COUNCIL ASSESSMENT REPORT

SNPP No	PPSSNH-363
DA Number	LDA2023/0001
Local Government Area	City of Ryde
Proposed Development	Demolition works, excavation, construction and occupation of a part 9, 13 & 14 storey development for a purpose-built student accommodation for 732 students. The proposal includes associated basement parking, communal open space areas, stormwater drainage works, landscaping and public domain improvements. This application is lodged as 'Co-Living Housing' under State Environmental Planning Policy (Housing) 2021.
Street Address	17-21 Lachlan Avenue & 163 Herring Road, Macquarie Park
Applicant/owner	Applicant: Urbis Owner: Lachlan Avenue Development Pty Ltd
Date of Lodgement	9 January 2023
Number of Submissions	5 submissions objecting to the proposal
Recommendation	Approval subject to conditions
Regionally Significant Development Criteria (Schedule 6 of SEPP (Planning Systems) 2021)	General Development over \$30 Million. Cost of works: \$120,150,000 (excluding GST)

Report prepared by	Tony Collier - Senior Town Planner
Report date	30 August 2023

Figure 25 – Four- and five-bedroom cluster units.

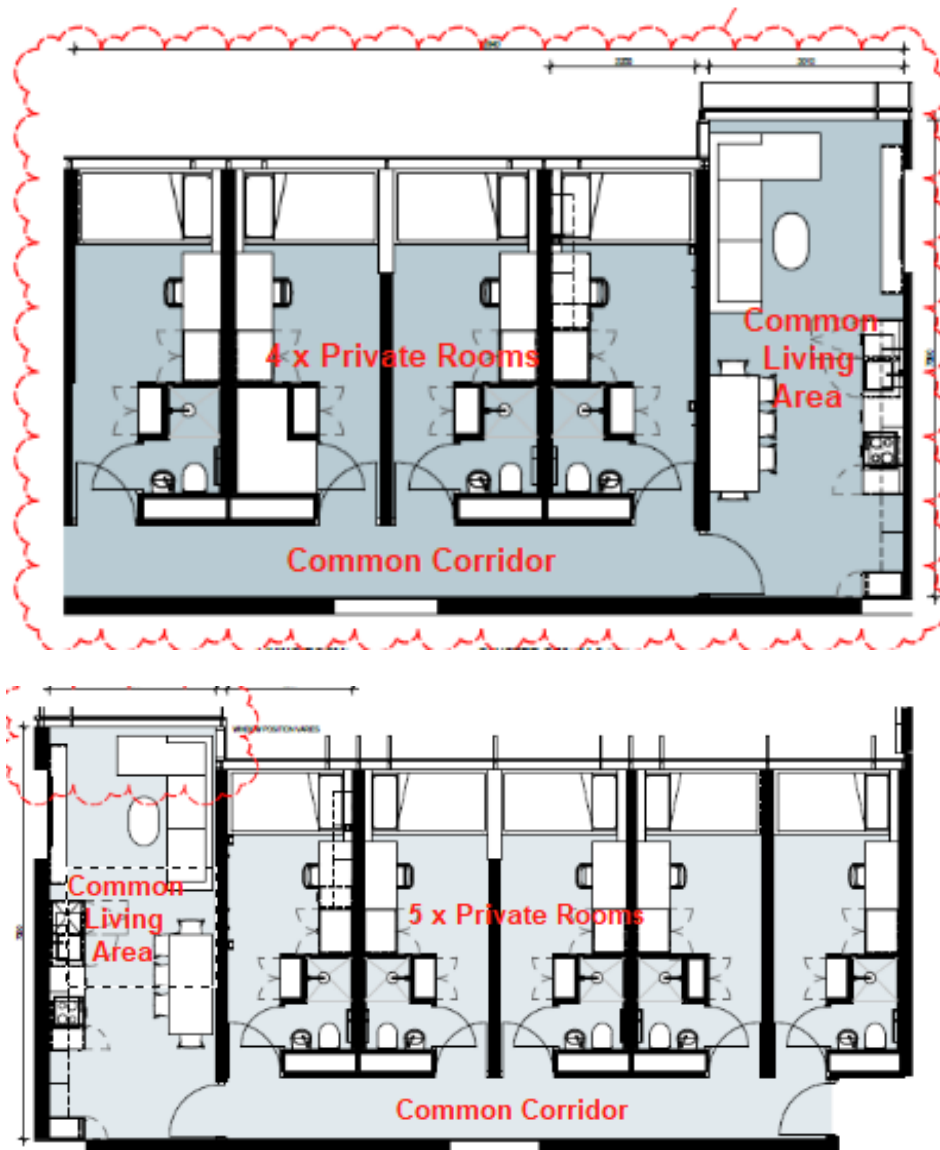
Figure 25 below shows the non-compliant rooms, in this instance designated as cluster rooms. Cluster rooms are a series of four or five private rooms which collectively share a common living room which includes a lounge area, kitchen, and dining area.

“Each cluster also includes a shared kitchen, dining and living area for the exclusive use of the residents living in the unit, with a minimum area of 18m² [Figure 25 above shows the shared living area as 22.17m²]. When the shared area is taken into consideration (as a portion according to the number of residents), the net living area of each bedroom can achieve the Housing SEPP requirement of 12m² per occupant. It is considered that the proposed rooms are an appropriate size and layout to ensure adequate privacy and amenity is maintained, whilst fostering community living that delivers a social and inclusive environment for residents.

Referring to **Figure 25**, the above statement may be expressed numerically as follows:

Figure 26 – Typical building separations at Levels 1 to 9 (side boundaries are marked in red).

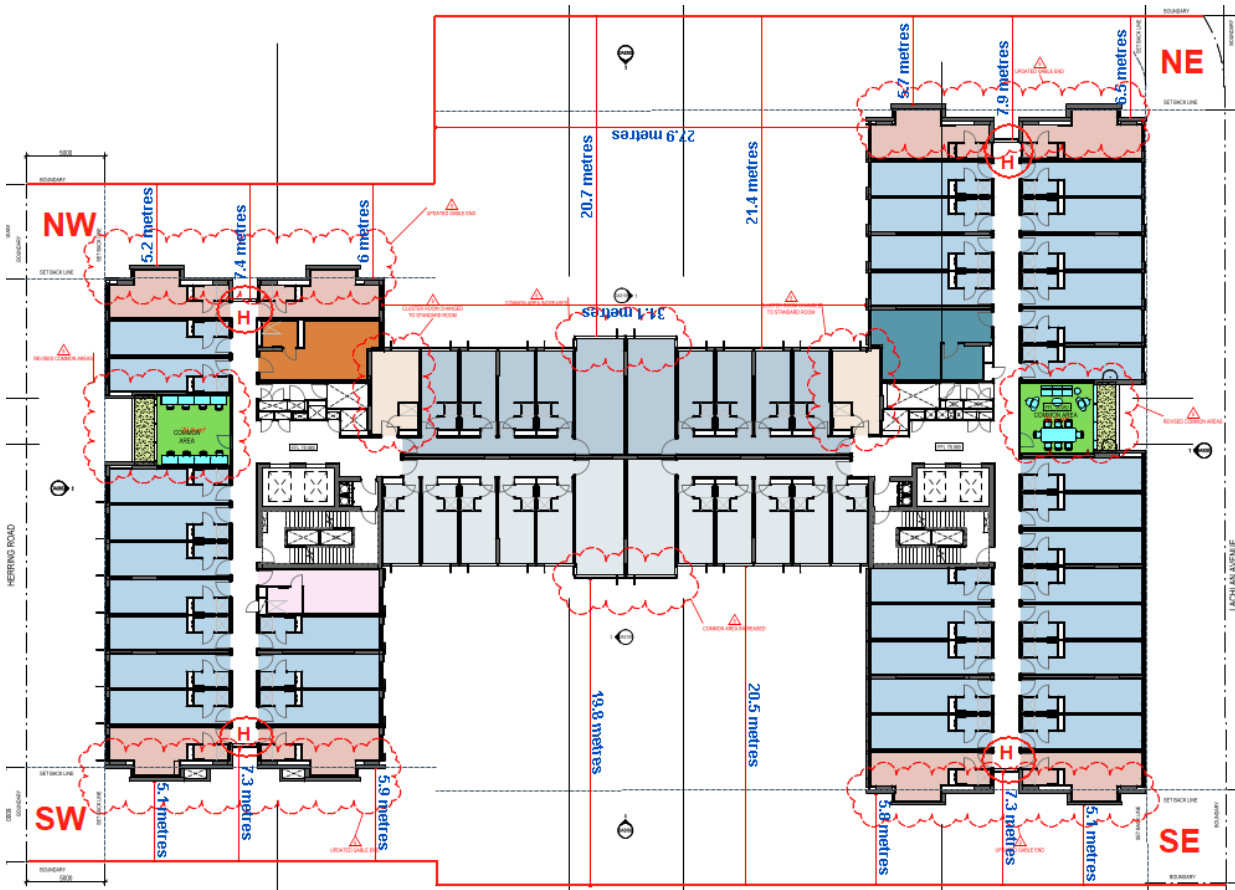
As can be seen in **Figure 26** above, the development includes blank walls which are situated at the ends of both north-south orientated wings. These blank walls include windows which service corridor ends at each level (circled in red and marked 'H').

As can be seen in **Figure 26** above, the development continues to include blank walls which are situated at the ends of both north-south orientated wings. These blank walls also include windows which service corridor ends at each level.

As noted earlier, the non-compliant windows are minor in that they comprise corridor-end windows only and are not regarded as high traffic areas because of their location at the end of each corridor (i.e., generally only the occupants of the rooms at the end of these sections would be transiting these areas for access/egress to rooms).

Notwithstanding, a condition is included to require these windows be treated with obscure film to prevent any overlooking opportunity (see the 'Conclusion' of this section).

Figure 27 – Building separations at Level 10 (side boundaries marked in red).

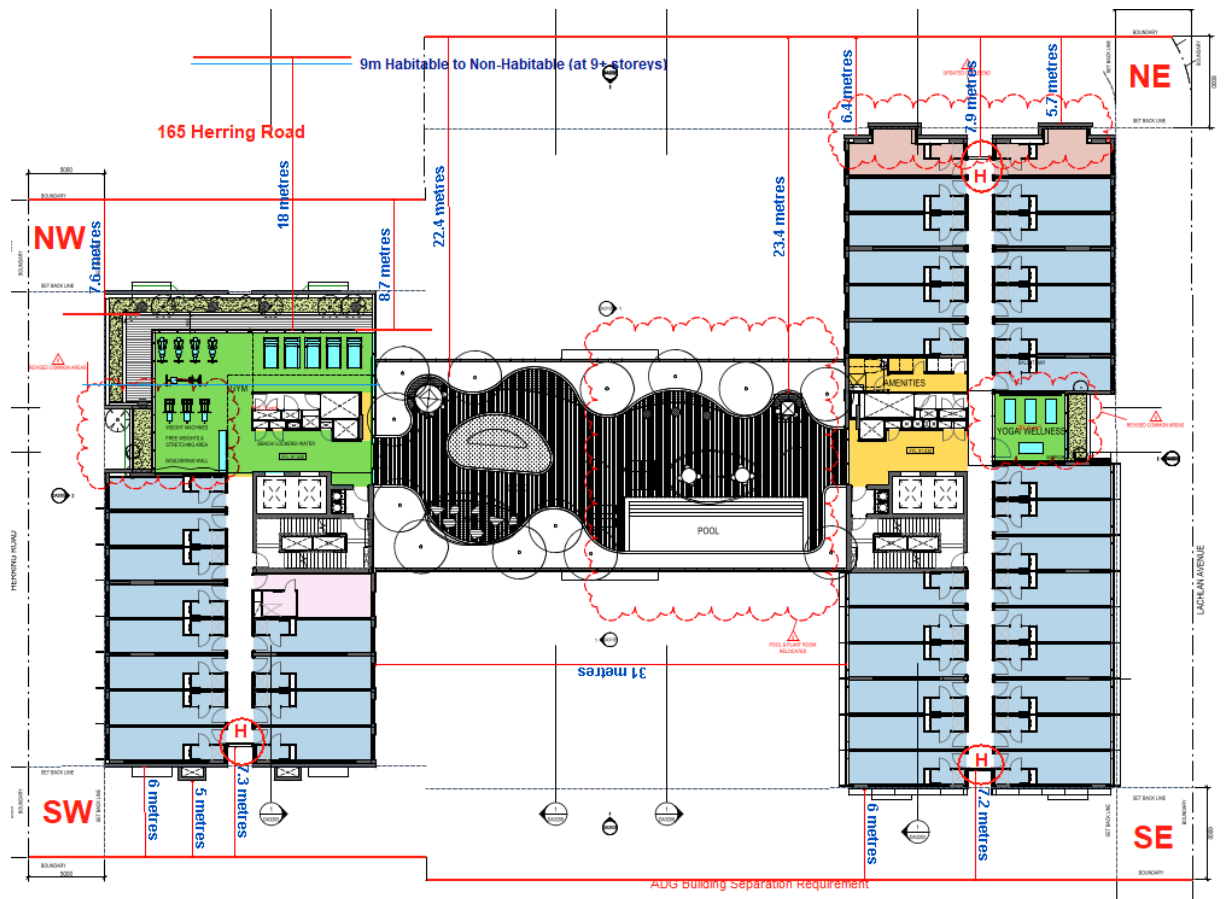
As can be seen in **Figure 27** below, the development continues to include blank walls which are situated at the ends of both north-south orientated wings. These blank walls also include windows which service corridor ends at each level.

Figure 29 – Cluster room setback from 165 Herring Road.

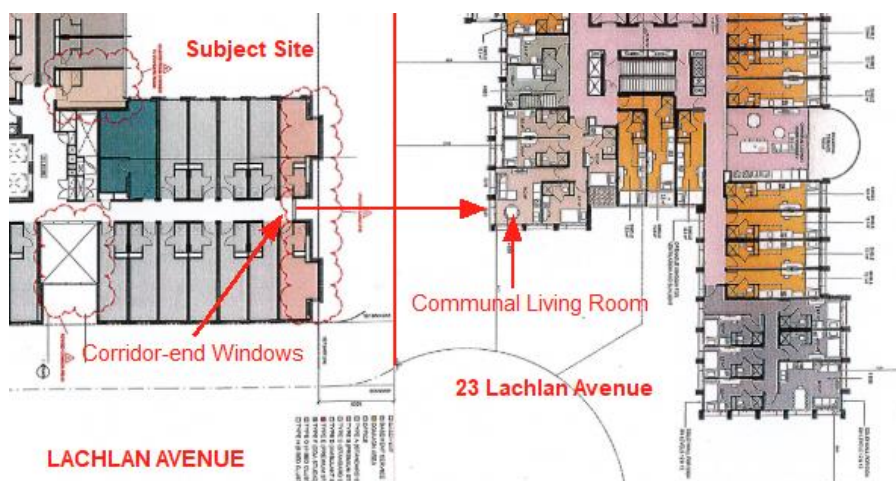
The north-eastern wing is adjacent to the recently approved boarding house and, on examination of the approved plans for that development, although physically separated by 16m, the proposed corridor-end windows will face windows of communal living rooms once that development is constructed. Therefore, the corridor-end windows at the north-eastern wing also require similar treatment (refer to **Condition 1(a)** in the draft consent).

Figure 29 below shows the proximity of corridor-end windows to the approved boarding house.

Figure 30 – Permitted 45m height plane (in pink) as viewed from the north-east (Lachlan Avenue).
Source: Plan DA0003 5 as prepared by AJC.

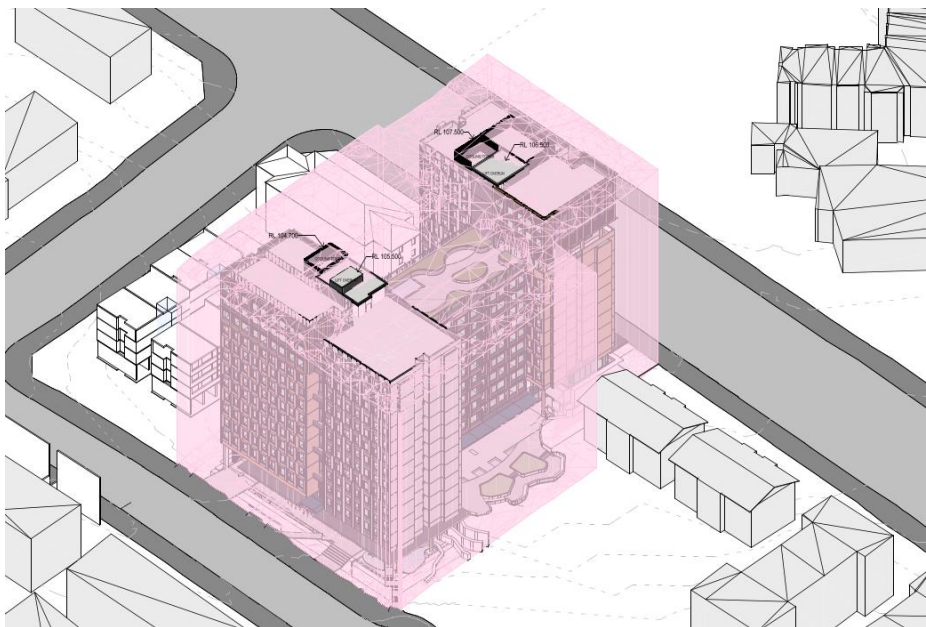
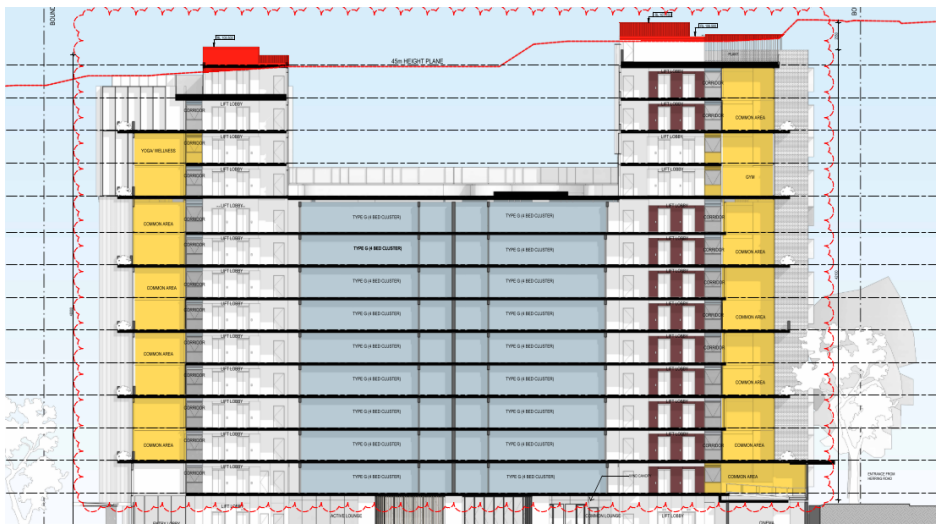
Clause 4.3 permits a maximum building height of 45m. The development proposes building heights of between 34m to 47.36m as noted in the table above. The non-compliance equates to a variation of 5.2% (+2.36m).

The non-compliant elements are illustrated in **Figures 30 and 31** below where it is noted that the development breaches the permitted building height at the uppermost section of the roof and rooftop plant.

Figure 38 – Amended windows.
Source: Plan DA4201 (Rev 7).

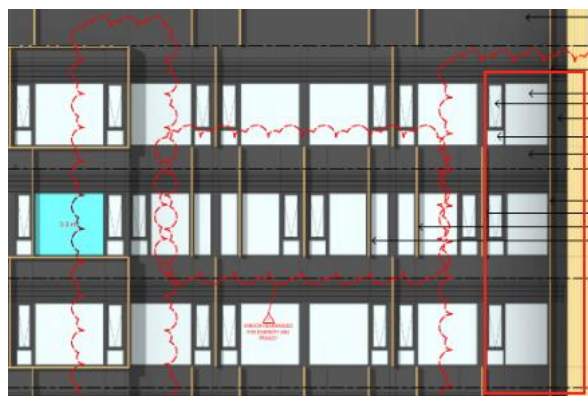
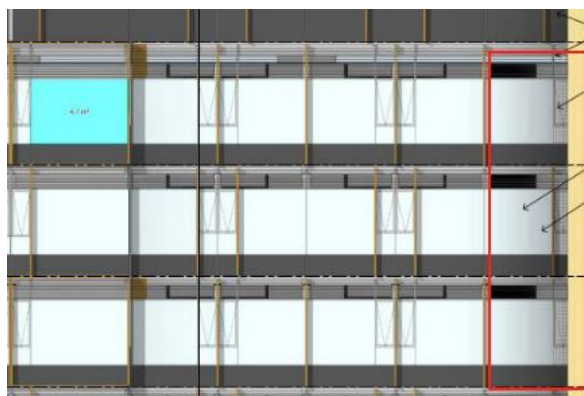
The obscure film originally proposed at the re-entrant corner has been replaced with a solid glazed cladding panel and a vertical fin which extends down the full height of the corners in question (see Plan DA4206 Revision 7). These features combined provide sufficient visual separation between adjacent rooms at re-entrant corners.

Figures 38 and 39 below show the amendment to the re-entrant corner windows (outlined in red).

Figure 40 – Amended vertical veil elements.
Source: Plan DA4206 (Rev 7).

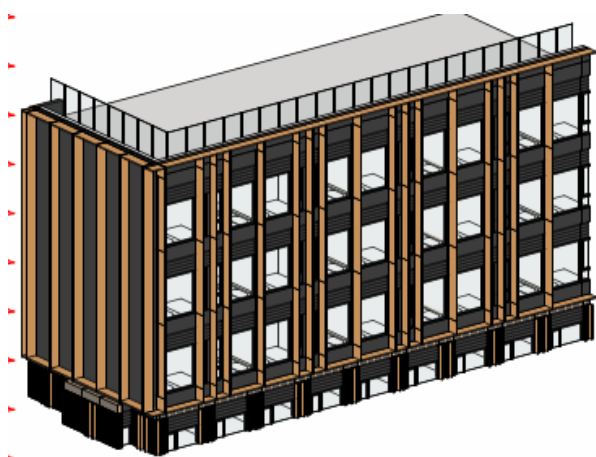
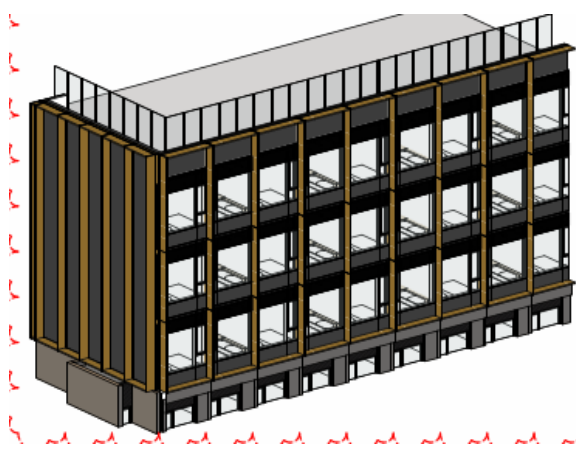
The vertical fins which were originally included in Plan DA4201 (Revision 4) have been reinstated in the current plan DA4201 (Revision 7). To clarify, Plan 4201 (Revision 6) excluded the grouping of three vertical fins which flattened the façade and diminished the sense of depth. The current revision provides a distinctive and perceptible architectural element when viewed from the public domain as a three-dimensional form.

Figures 40 and 41 below show the amended 'veil' facing Lachlan Avenue.
